STATE OF RHODE ISLAND AND PROVIDENCE PLANTATION
DEPARTMENT OF TRANSPORTATION
RHODE ISLAND CONTRACT NO.2012-CH-082
FEDERAL-AID PROJECT NO. FAP Nos: STP-0044(062), STPG-0044(063)

Imp. to Rte. 44 Contract 2B - Austin Avenue to Danecroft Avenue

NOTICE TO PROSPECTIVE BIDDERS

ADDENDUM NO. 1 Prospective bidders and all concerned are hereby notified of the following changes in the Plans, Specifications, Proposal and Distribution of Quantities for this contract. These changes shall be incorporated in the Plans, Specifications, Proposal and Distribution of Quantities, and shall become an integral part of the Contract Documents.

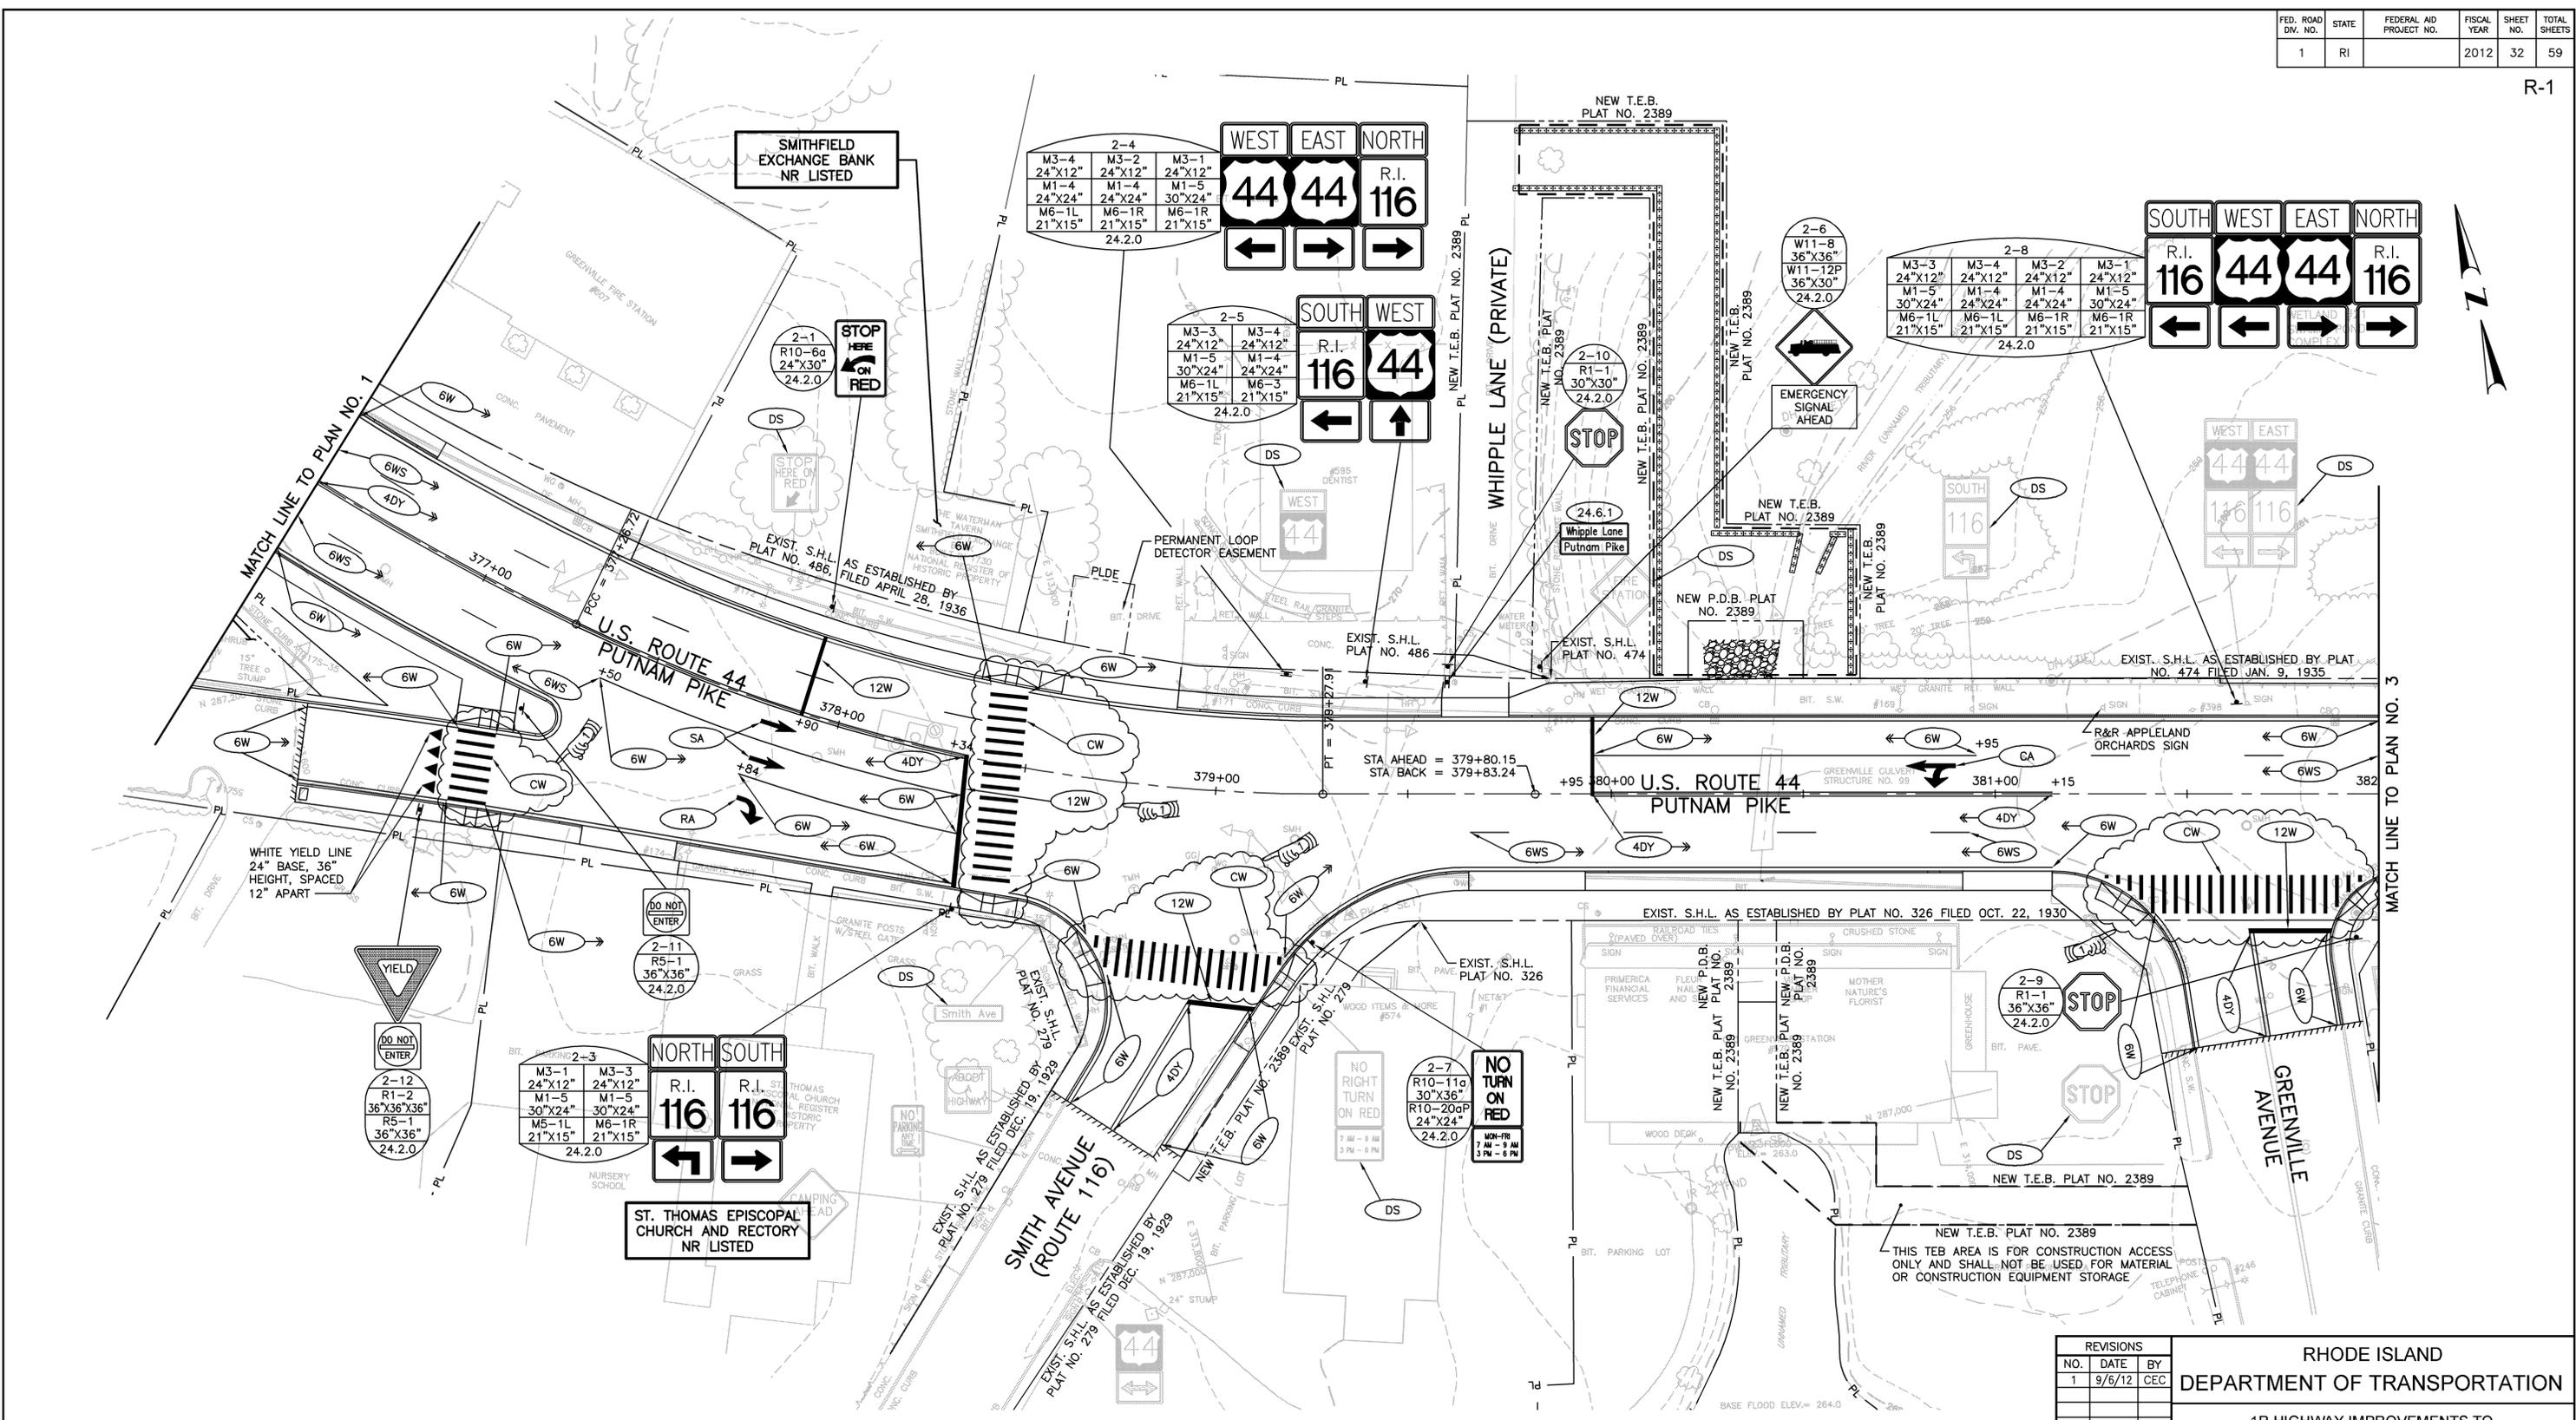
Remove Sheet No. 5 (Job Specific Plan Symbols, Legend and Notes) in its entirety and replace it with revised Sheet No. 5(R-1) attached to this Addendum No. 1. The pavement marking legend for crosswalks has been revised.

**SIGNING AND PAVEMENT
MARKING PLAN NO. 2**

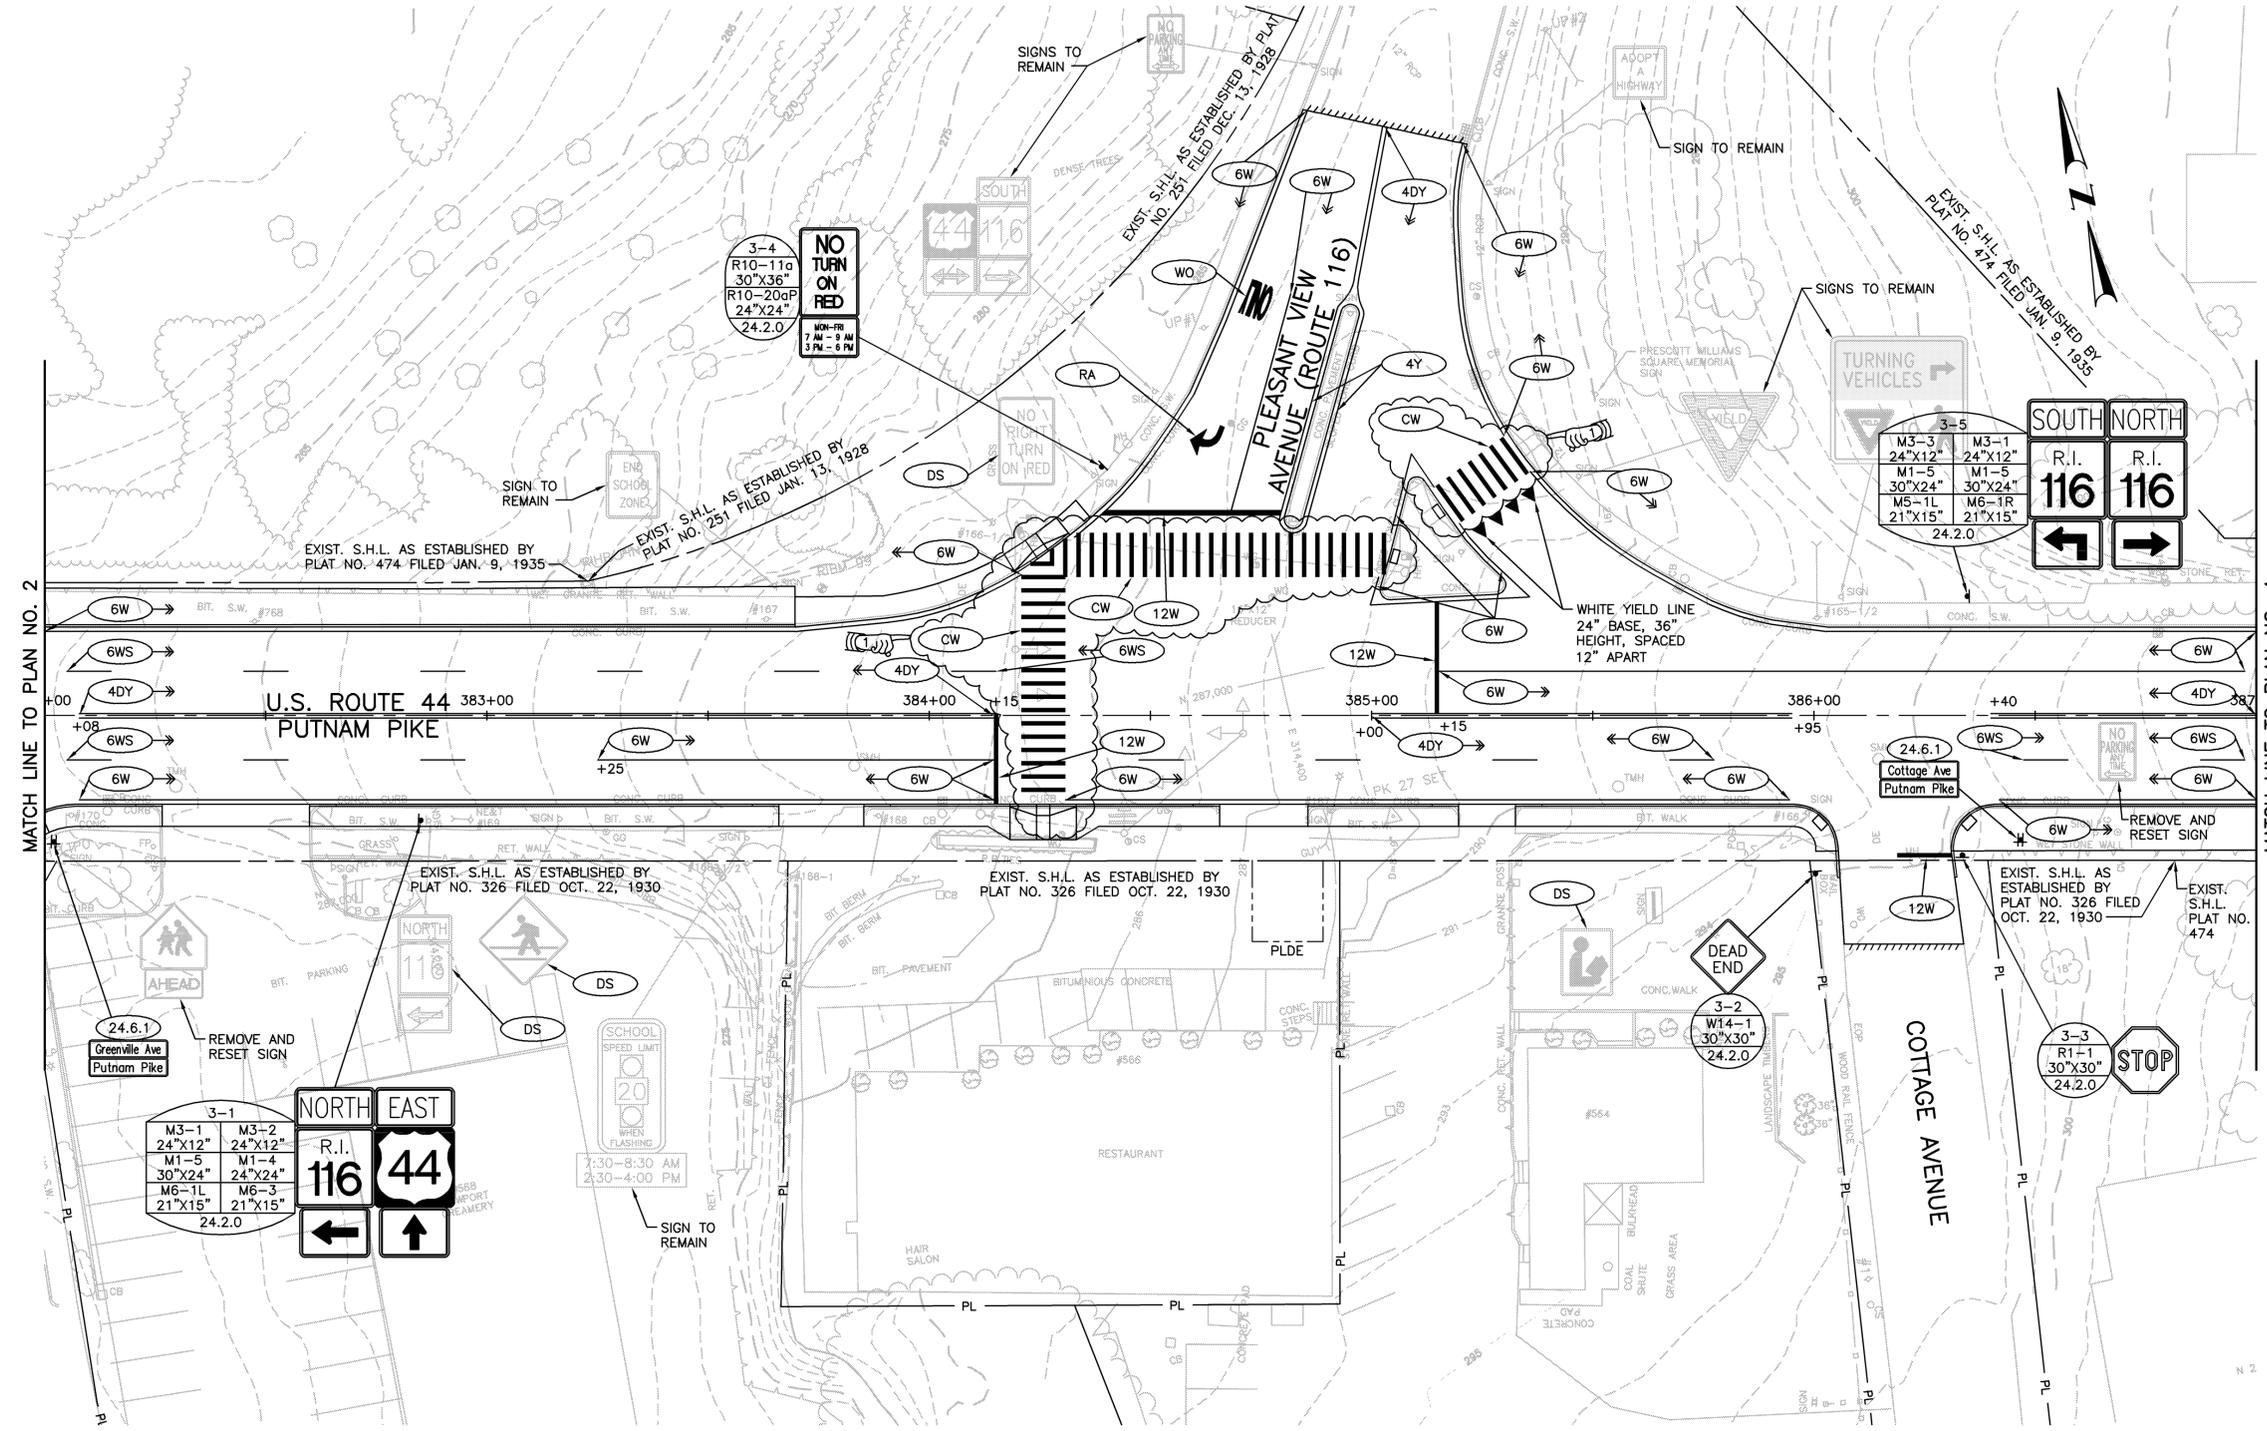
Remove Sheet Nos. 32 and 33 (Signing and Pavement Marking Plan Nos. 2 and 3) in their entirety and replace them with revised Sheet Nos. 32(R-1) and 33(R-1) attached to this Addendum No. 1. The pavement markings at crosswalks have been revised.

SIGNAL PLAN NO. 1
 AUSTIN AVENUE & PUTNAM PIKE
 SIGNAL NO. 770

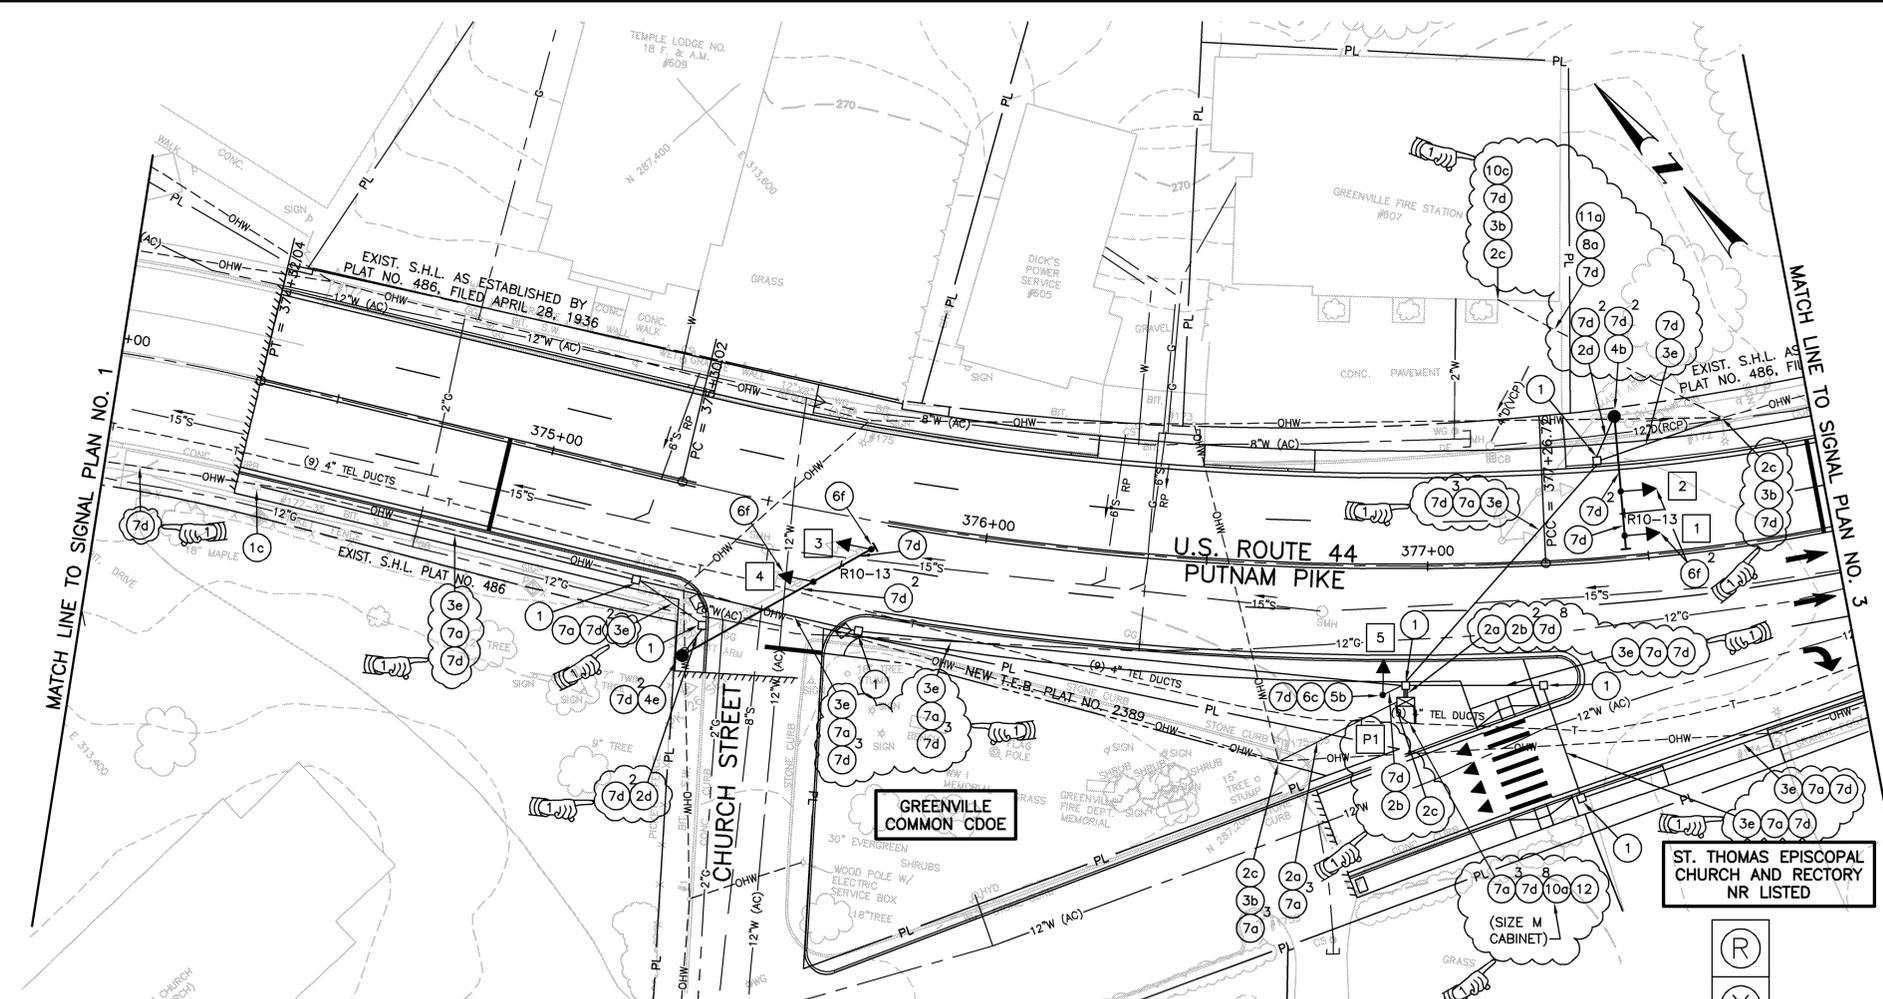
Remove Sheet Nos. 39 through 45 in their entirety and replace them with revised Sheet Nos. 39(R-1) through 45(R-1) attached to this Addendum No. 1. The traffic signal equipment, materials and details have been revised.
